DESCRIPTIVE REPORT

Type of Survey SHORELINEField No. _____ Office No. T-10728

State ALASKAGeneral locality KUIU ISLAND - SUMNER STRAITLocality HEAD OF KELL BAY1955

REVIEW REPORT T-10728

COMPARISON PRINT

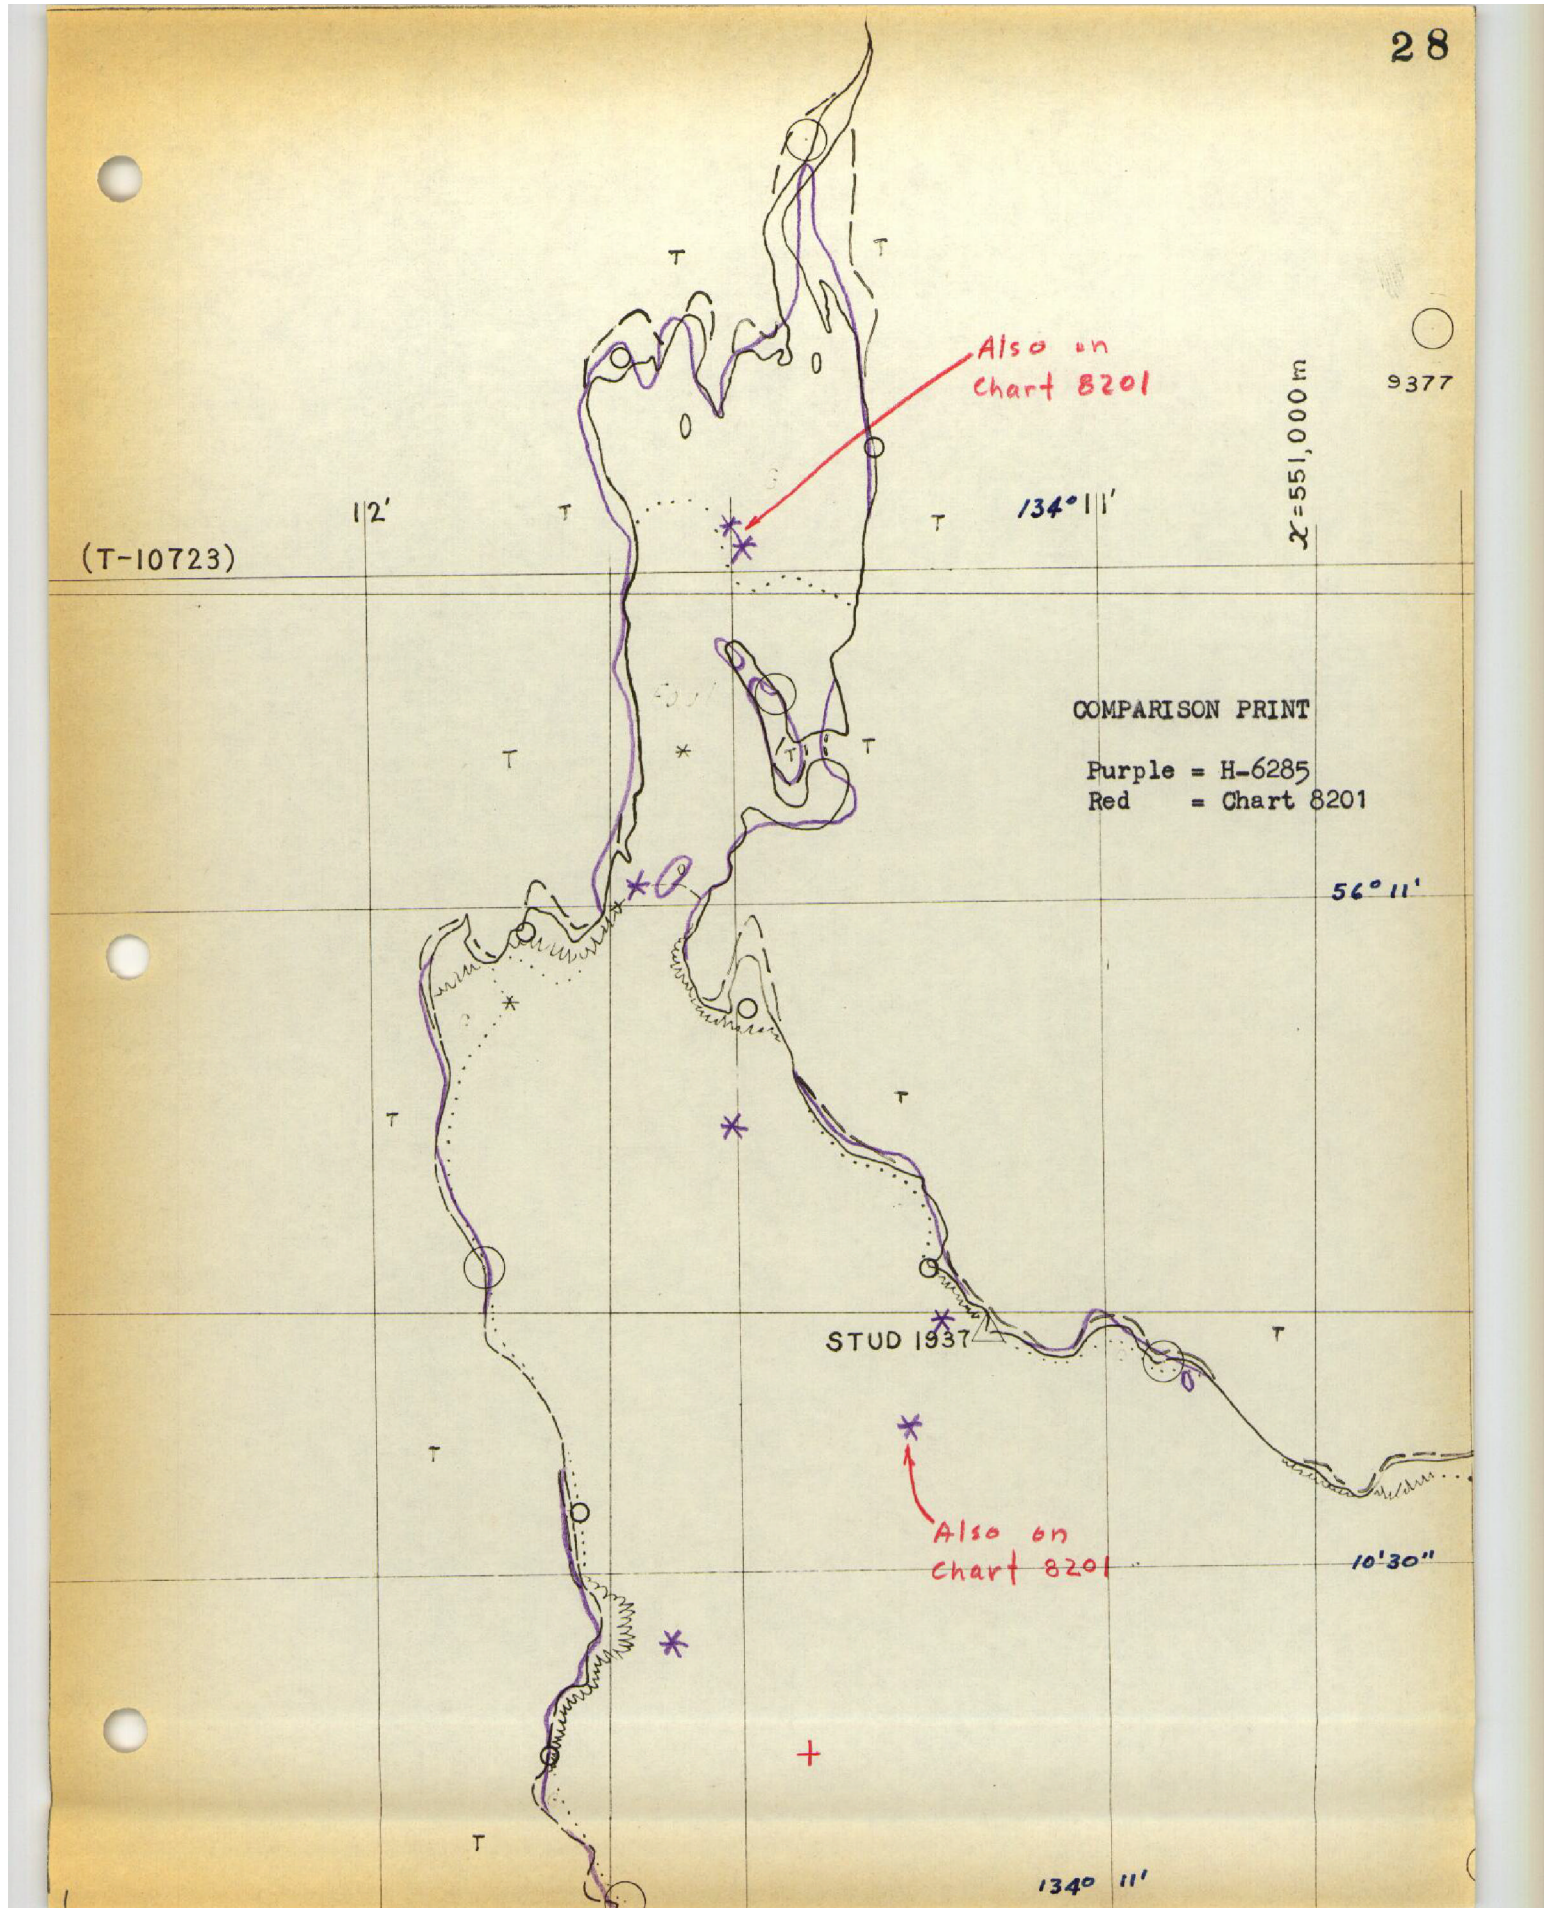
A comparison was made with a copy of the smooth sheet for Survey H-6285, scale 1:20,000, dated July-August 1937 and August 1938. Significant differences between this survey and T-10728 are shown in purple on the comparison print.

Several rocks awash mapped by the hydrographer were not visible on the photographs and were not mapped on T-10728.

A visual comparison was made with Chart 8201, scale 1:217,828, 16th edition, dated 7 November 1970. Significant differences are noted in red on the comparison print.

Also on
chart 8201
